Urgent Field Safety Notice

MiniMed™ 780G insulin pump

Pump Errors After Quick Bolus - Software Update

Medtronic reference: FA963

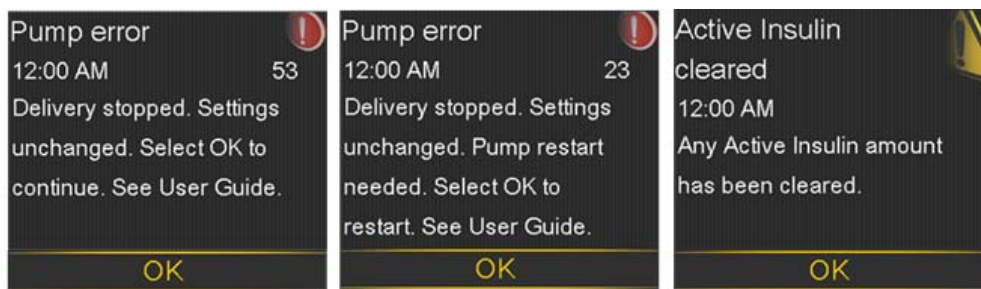
A software issue was identified in the MiniMed™ 780G pump with software version 6.5 when a large bolus is delivered at quick bolus speed.

This issue may result in pump errors if ALL of the following conditions are met:

- You have a MiniMed™ 780G pump with software version 6.5 and have not upgraded to software version 6.7.
- The bolus delivery speed is programmed to “Quick” in the pump settings (default is “Standard”).
- The SmartGuard™ feature is in use.
- The pump needs to be on the bolus delivery screen when an auto correction bolus is triggered. *Auto corrections are triggered when sensor glucose (SG) is running high and Active Insulin is low.*
- The bolus amount programmed to be delivered is greater than 17.1U.

Note: This can be a single bolus greater than 17.1U or a combination of boluses totaling greater than 17.1U.

If all the above conditions are met, within 2 minutes of bolus delivery completion, the pump initiates Pump error 53, followed by Pump error 23 alarm. The following screens are presented in the pump screen:

ACTIONS REQUIRED FOR SOFTWARE VERSION 6.5:

Upgrade your MiniMed™ 780G insulin pump software to version 6.7 using one of the three options below:
